# Request for Interpretation Response

Project Name: Surgical Tech Sim Suite
Project No.: 26053
Owner: NWACC

RFI NO: **01**
Date of Request: 11/5/2026
Date of Response: 11/6/2026

SECOND FLOOR LIGHTING PLAN

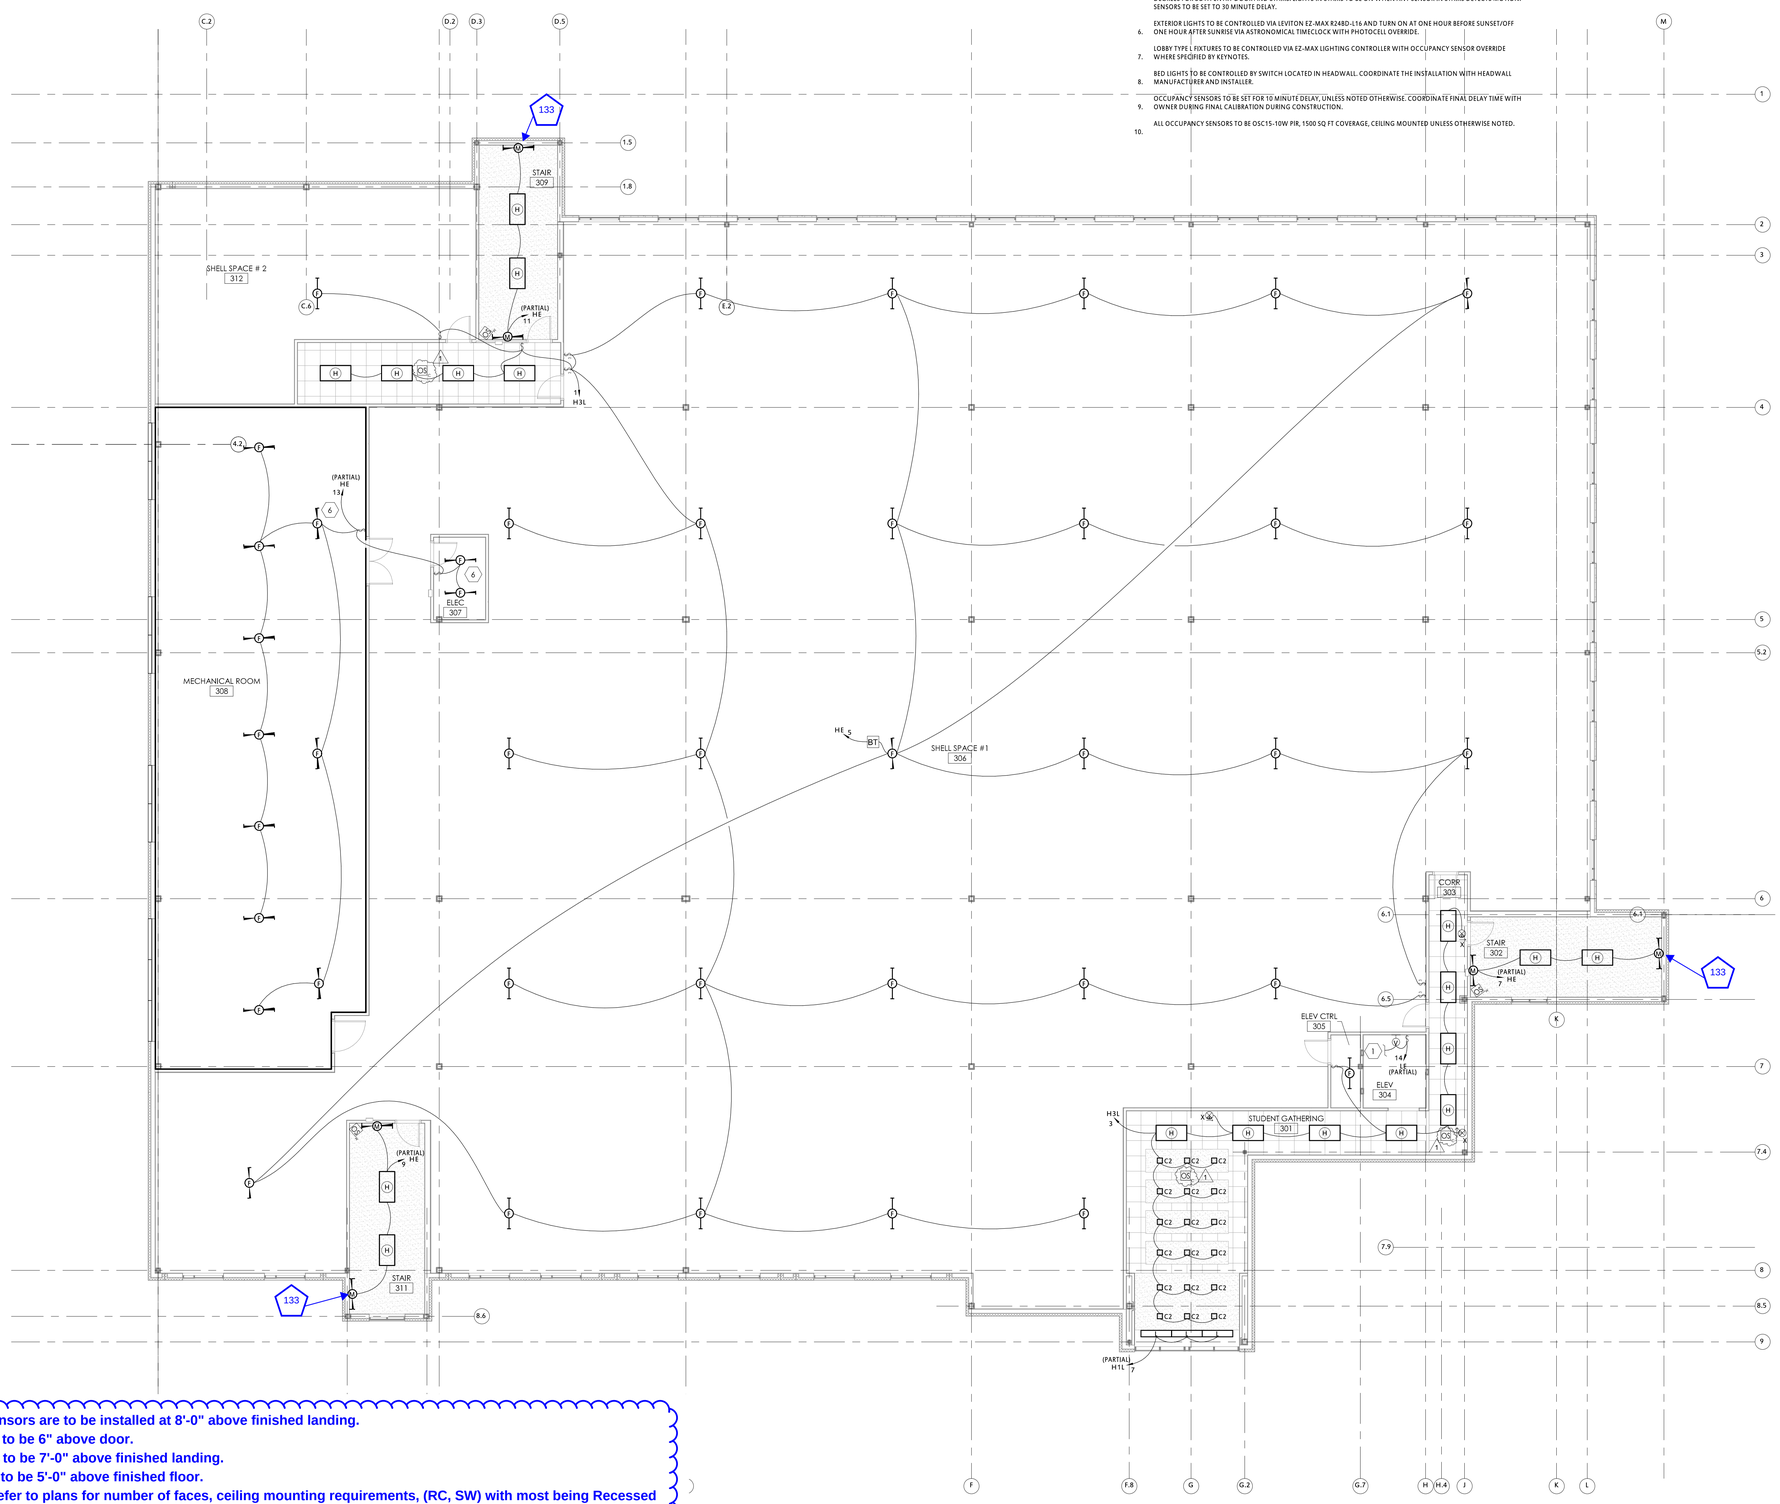
Item 16) ***Revision*** RE: Attached E-101 through E-103 for revisions to the lighting plans (1st through 3rd floor).

CHANGES TOO NUMEROUS TO CLOUD, REVIEW ENTIRE SHEET FOR OCCUPANCY SENSOR CHANGES

1 SECOND FLOOR POWER AND COMMUNICATIONS PLAN
1/8" = 1'-0"

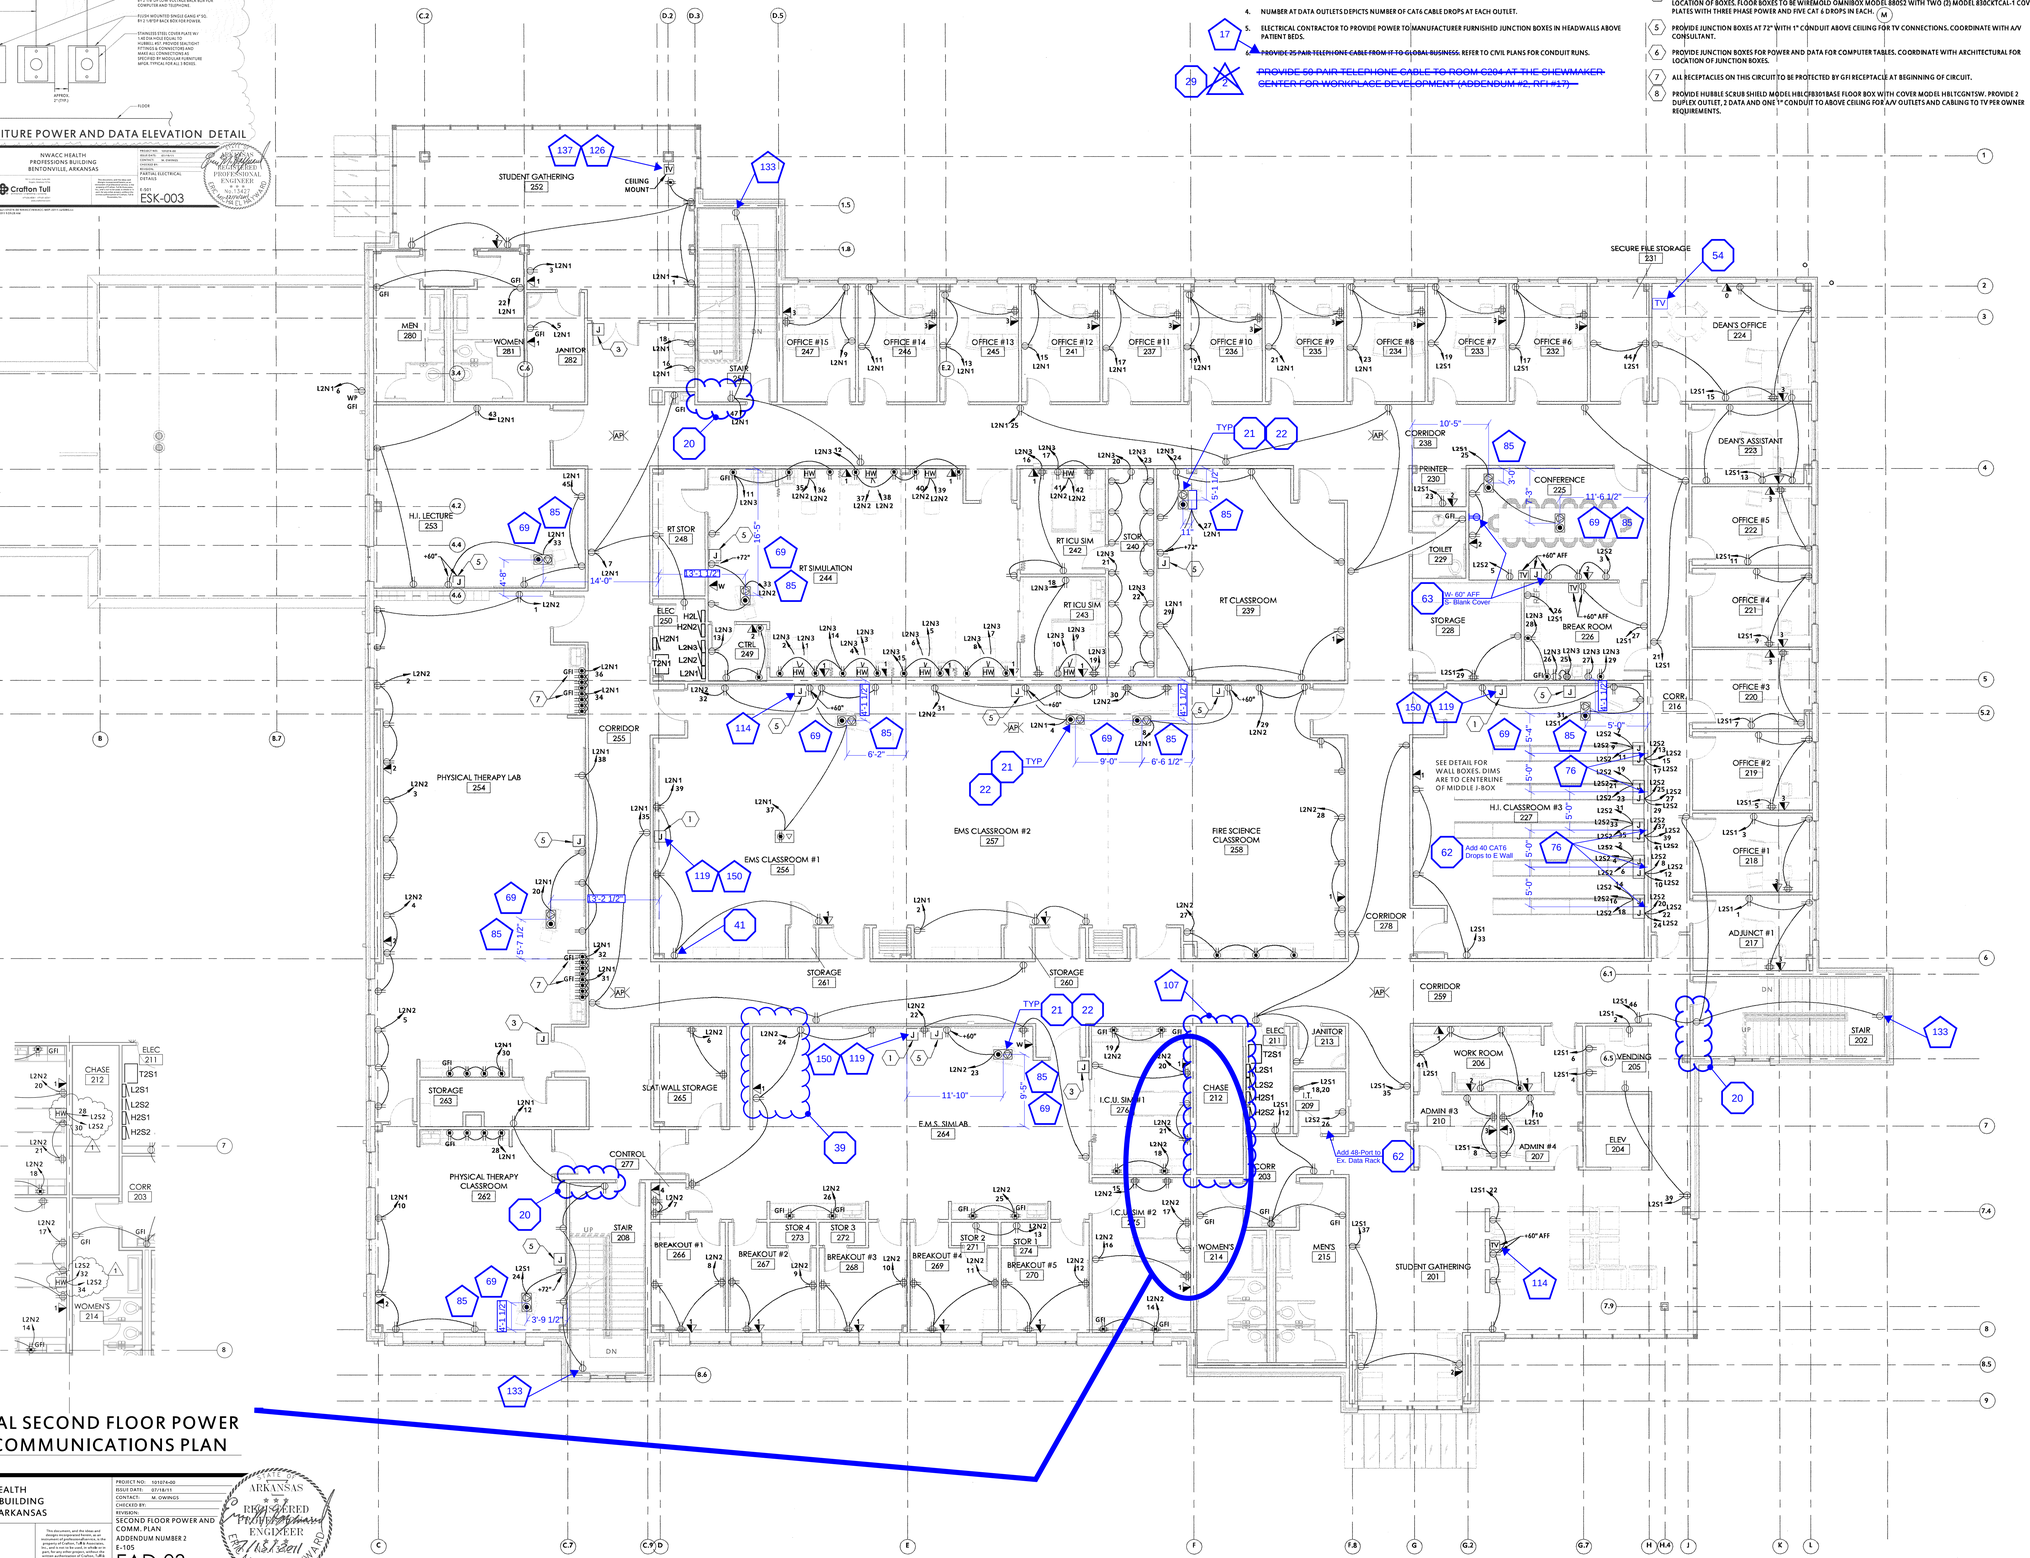
Item 17) ***Revision*** RE: General Notes, Sheets E-104 through E-106, Note number 6 should call for 50 pair telephone cable to be run to Room C204 at the Shewmaker Center for Workforce Development.

1 THIRD FLOOR POWER AND COMMUNICATIONS PLAN
1/8" = 1'-0"

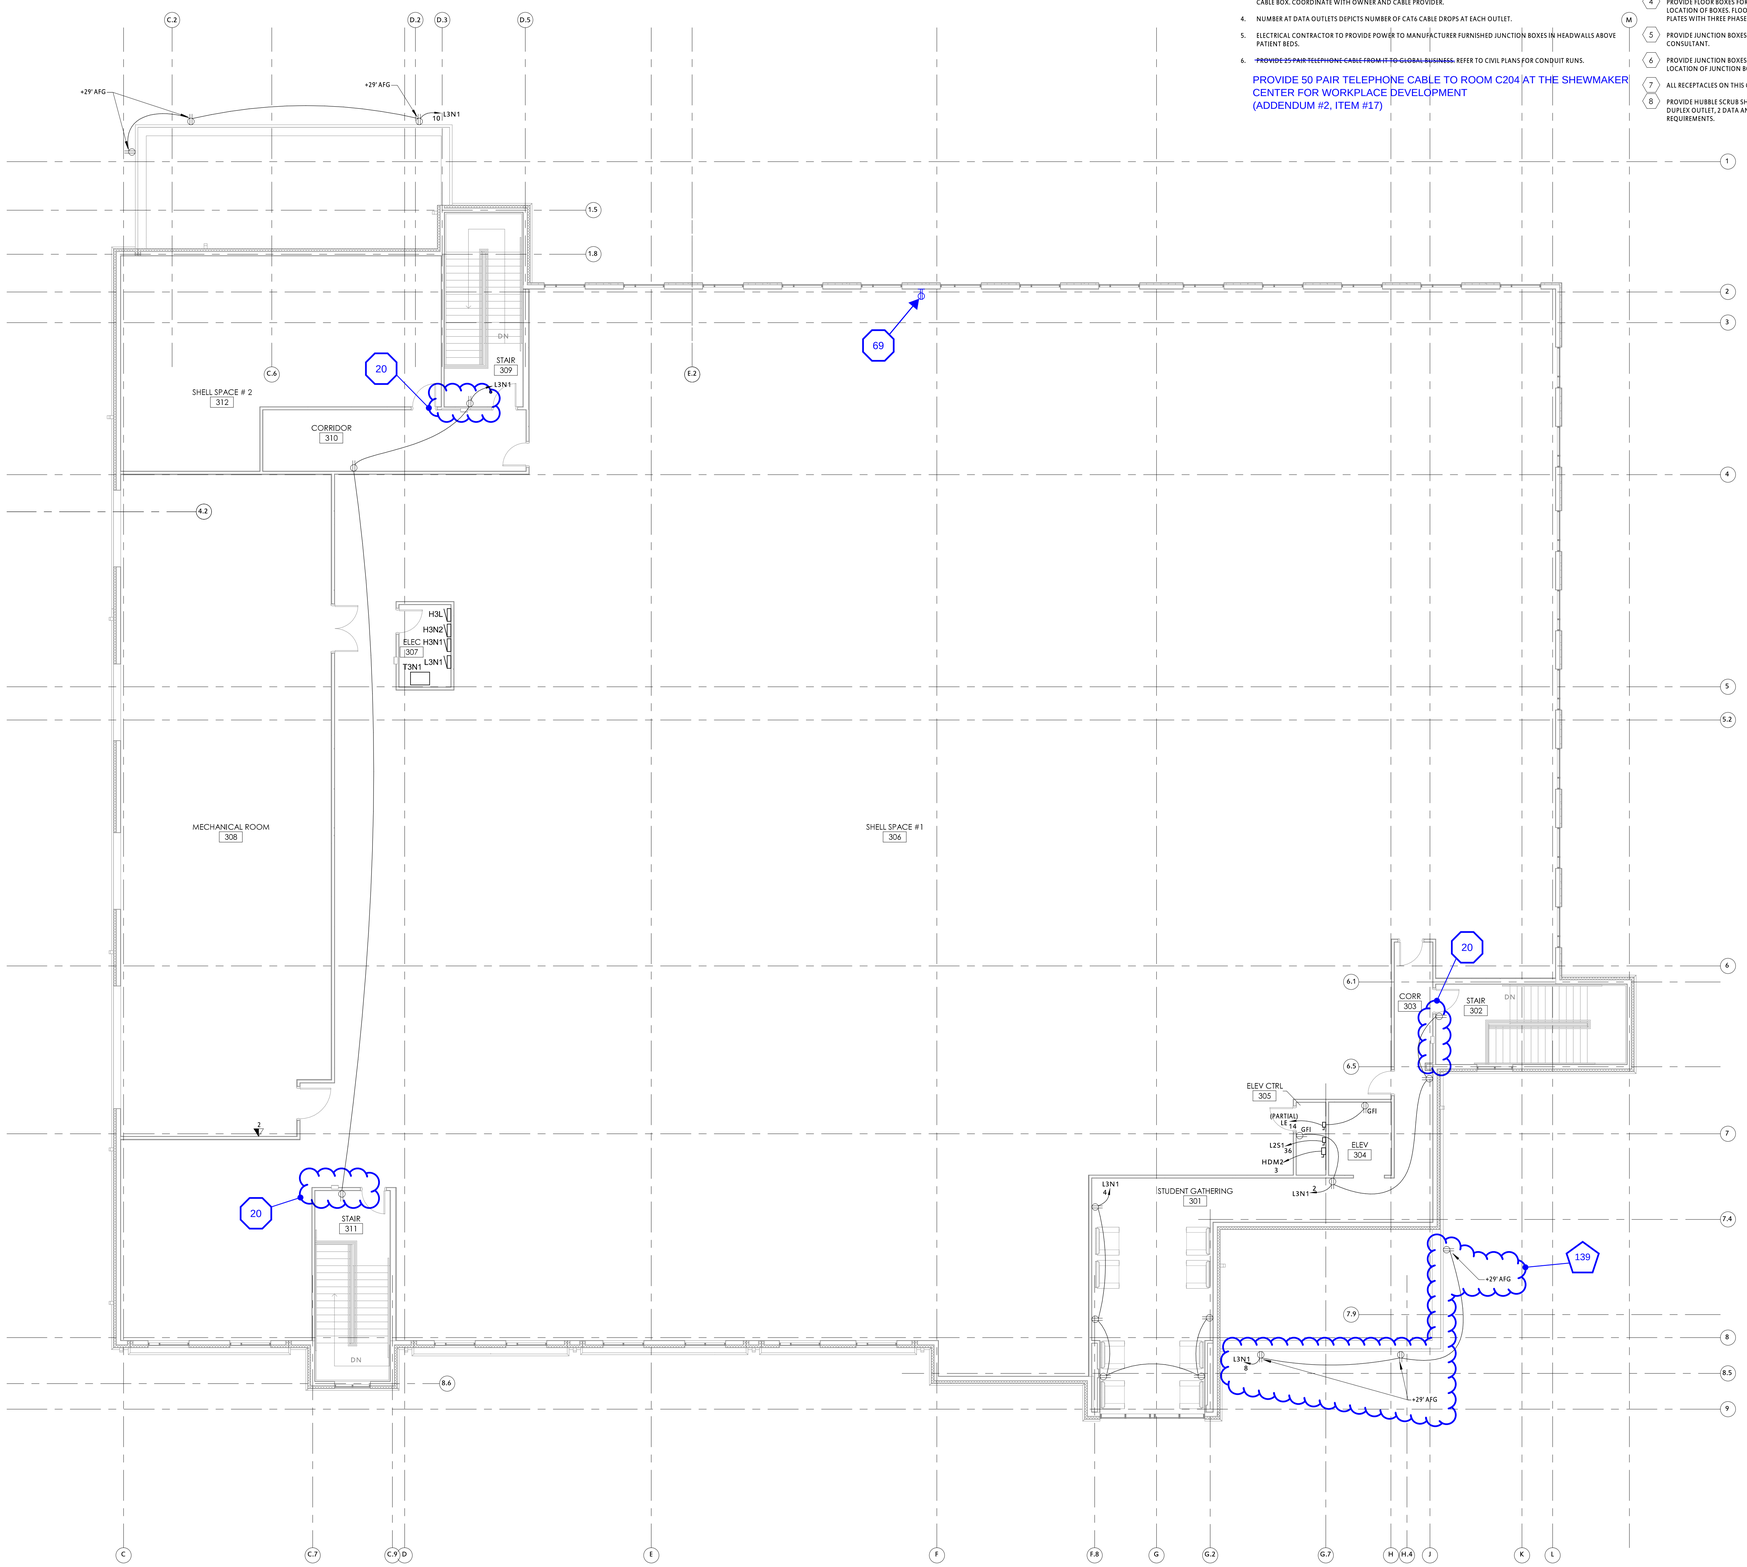
2 Item 17) ***Revision*** RE: General Notes, Sheets E-104 through E-106, Note number 6 should call for 50 pair telephone cable to be run to Room C204 at the Shewmaker Center for Workforce Development.

PROVIDE 50 PAIR TELEPHONE CABLE TO ROOM C204 AT THE SHEWMAKER CENTER FOR WORKPLACE DEVELOPMENT
(ADDENDUM #2, ITEM #17)
